# MEMORANDUM

**To:** Seguin Planning and Zoning Commission  
**From:** Kyle Warren, Planner  
**Subject:** Jefferson Place, Unit 2 – Final Plat  
**Date:** July 31, 2024

**JEFFERSON PLACE UNIT TWO**  
 2.571 AC. LOCATED IN THE  
 H. BRANCH SURVEY, A-6  
 SEGUIN, GUADALUPE COUNTY, TEXAS  
 BETTERS WORTH & ASSOCIATES, INC.  
 111 EAST MOUNTAIN STREET, SEGUIN, TEXAS 78155  
 PH: 830.379.5552 FX: 830.379.5553  
 E-MAIL: ken@bettersworthassoc.com  
 ENGINEERING FIRM NO. F-11731  
 SURVEYING FIRM NO. F-10128700

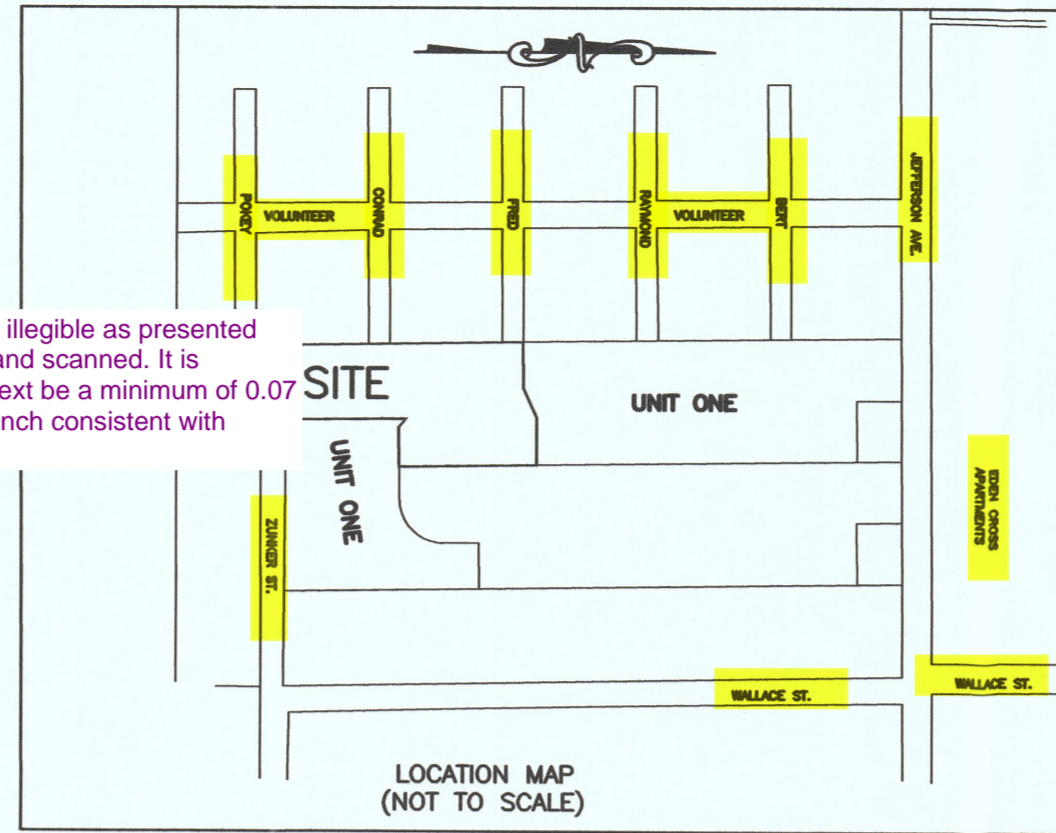
- Update panel and date on FEMA note
- Remove restrictive covenants in the right-of-way
- Remove utilities from plat
- Preamble is incomplete (UDC Technical Manual, Engineering Checklist)
- Edit/update surrounding properties deed and document number references (UDC Technical Manual, Engineering Checklist)
- Miscellaneous labeling issues (UDC, Technical Manual)
- Signature block corrections needed (UDC Technical Manual, standardized signature blocks)
- Add fee-in-lieu parkland dedication note to plat notes

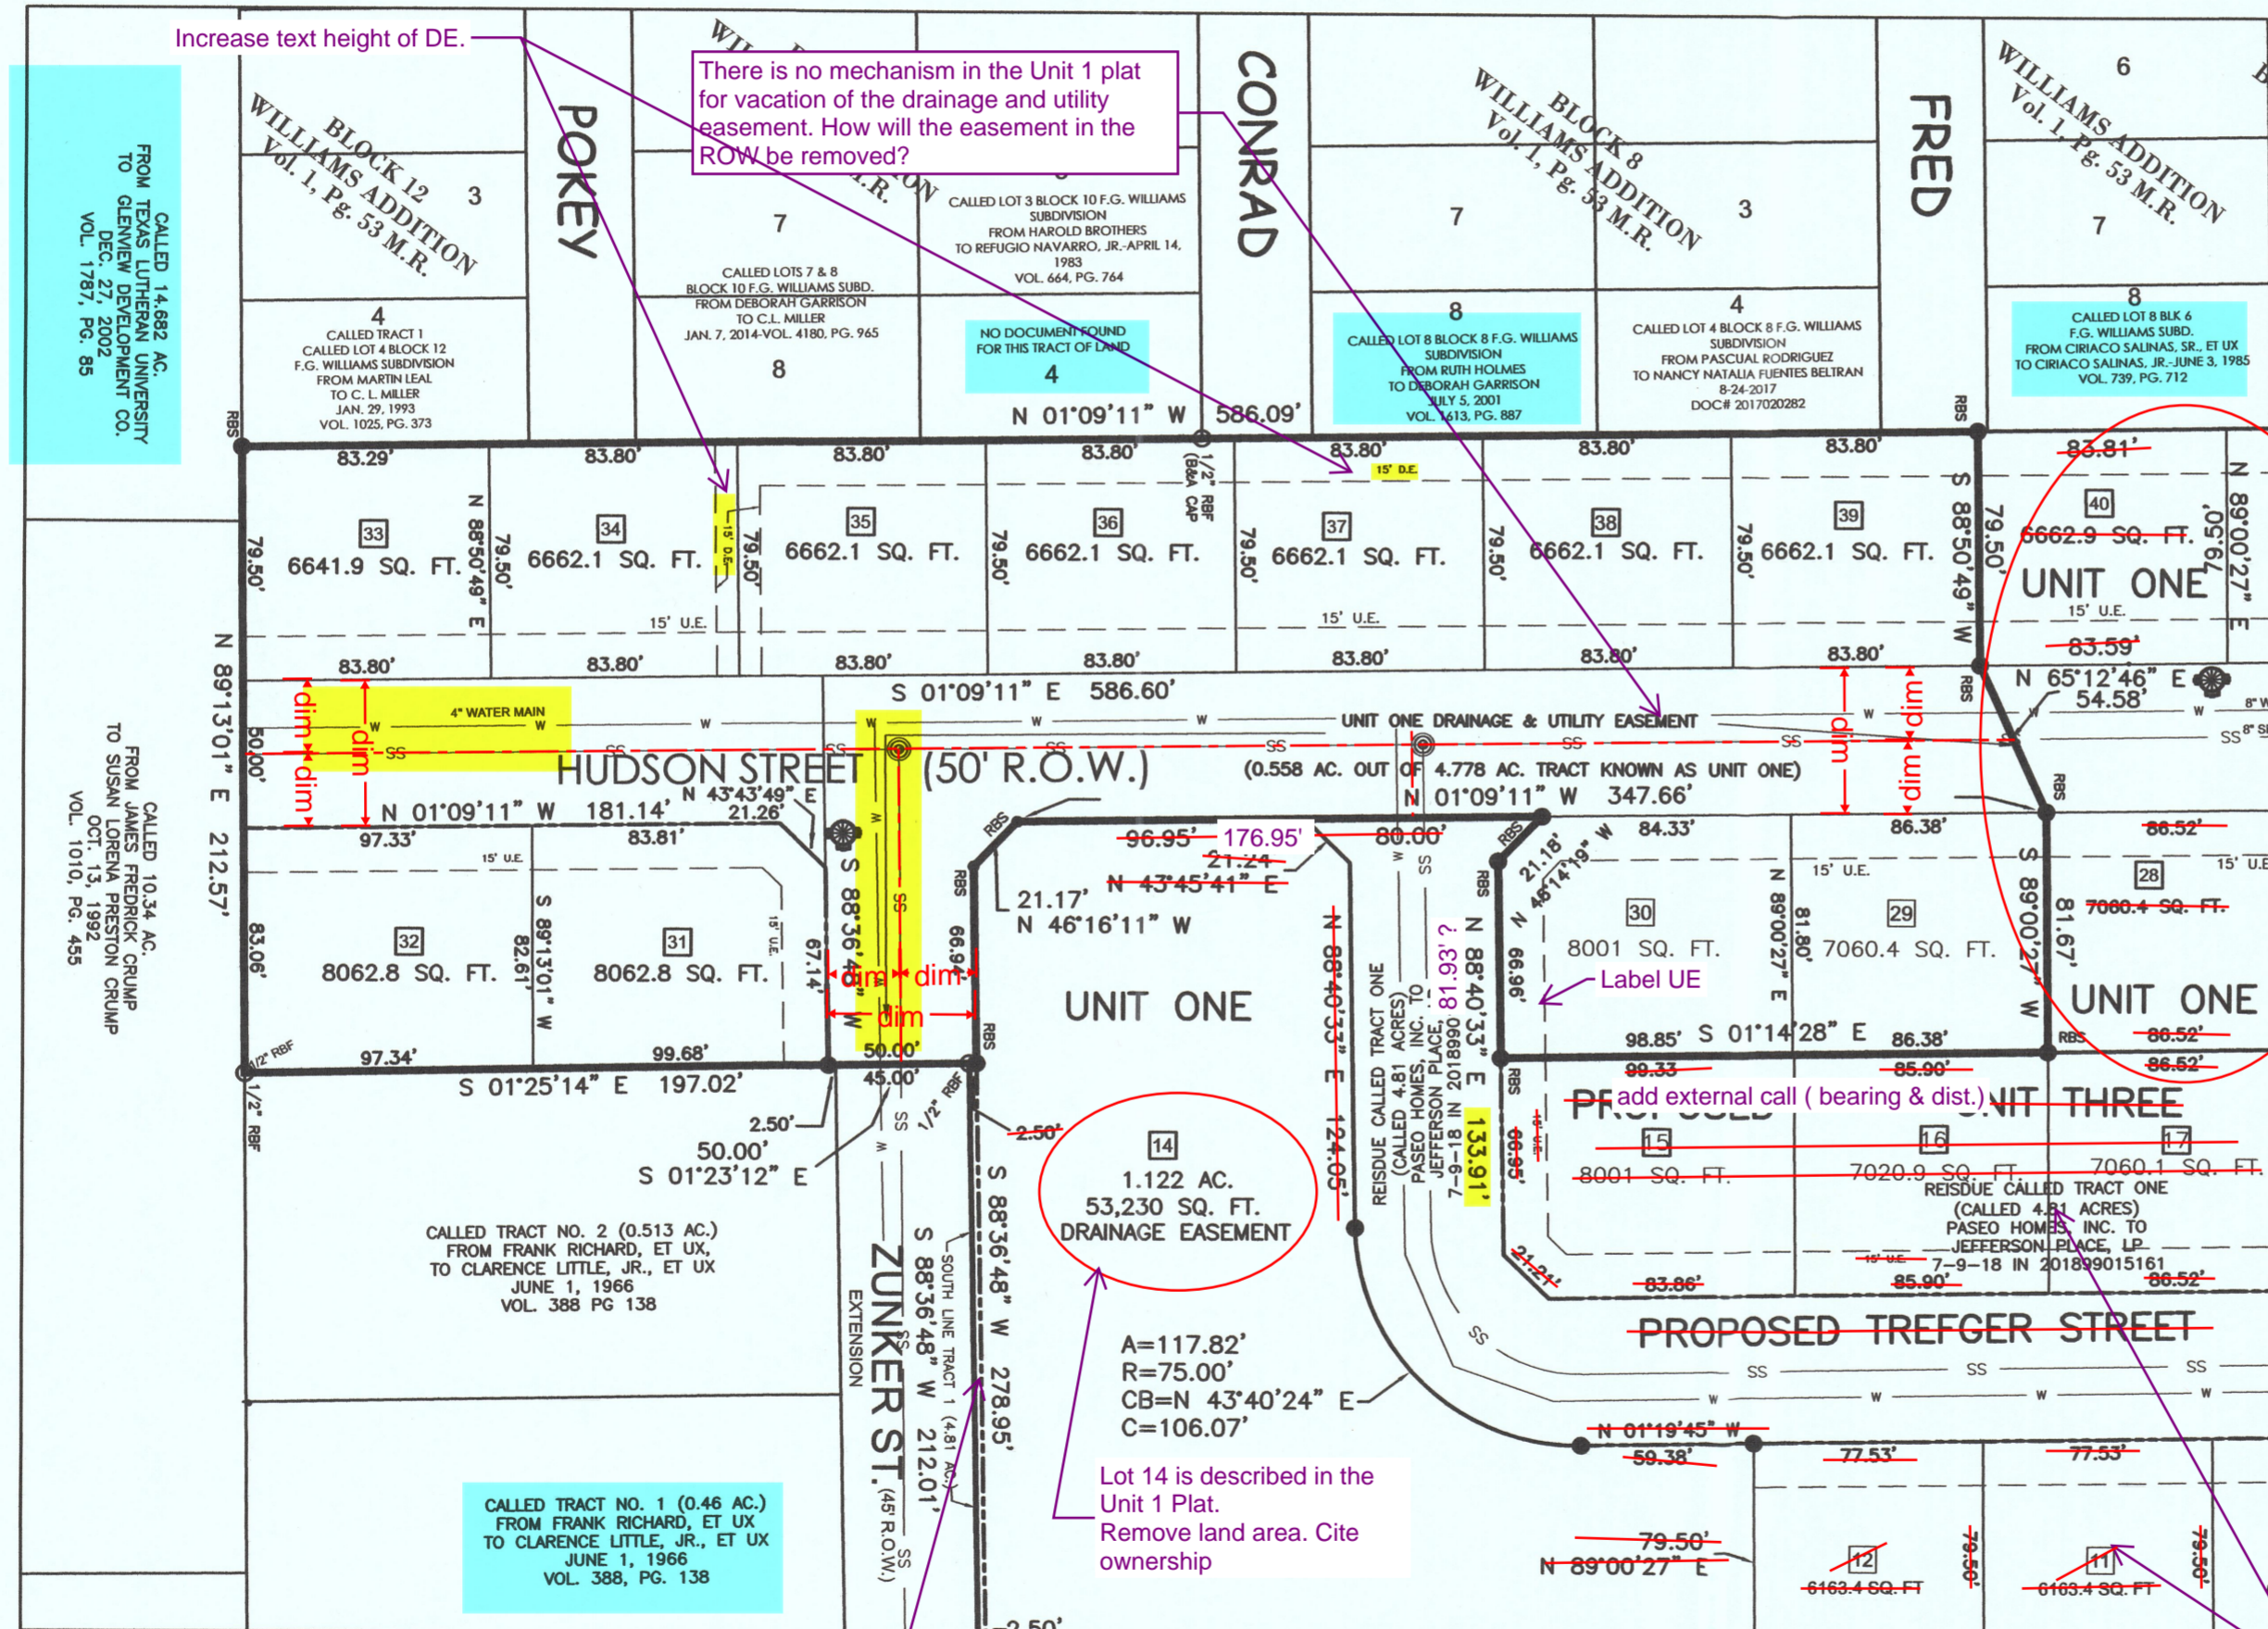
Remove. Not relevant information to this plat.

increase text height. illegible as presented and once recorded and scanned. It is recommended that text be a minimum of 0.07 inch, preferably 0.1 inch consistent with drafting standards.

Please add the following Note:  
 This is a 100% fee-in-lieu of parkland dedication and development subdivision. The developer will pay the fee-in-lieu of parkland dedication and development in

See Seguin's technical Manual for correct signature blocks.

- 2.) Water is to be supplied by City of Seguin. Check panel and date.
- 3.) Electricity is to be supplied by City of Seguin.
- 4.) Sanitary Sewer is to be supplied by City of Seguin.

provide citation for Unit 1. identify ownership of adjoining lots.

Remove all references of Unit 3. Depict current adjacent property. PID #51423, owned by Jefferson Place LP. cite deed.

A 4" x 3" tall clear space shall be provided on the plat for the County Clerk Recordation stamp.

There is no mechanism in the Unit 1 plat for vacation of the drainage and utility easement. How will the easement in the ROW be removed?

Increase text height of DE.

Information is no longer valid. Update adjoining properties

remove utilities from ROW. Depict centerline, dimension roadway which locate the centerline.

This block lacks a preamble which includes current ownership of the land and deed reference.

BASIS OF BEARINGS: Add scale  
 GRID NORTH SCALE: 1" = XX'  
 GPS OBSERVATION 12-26-2017
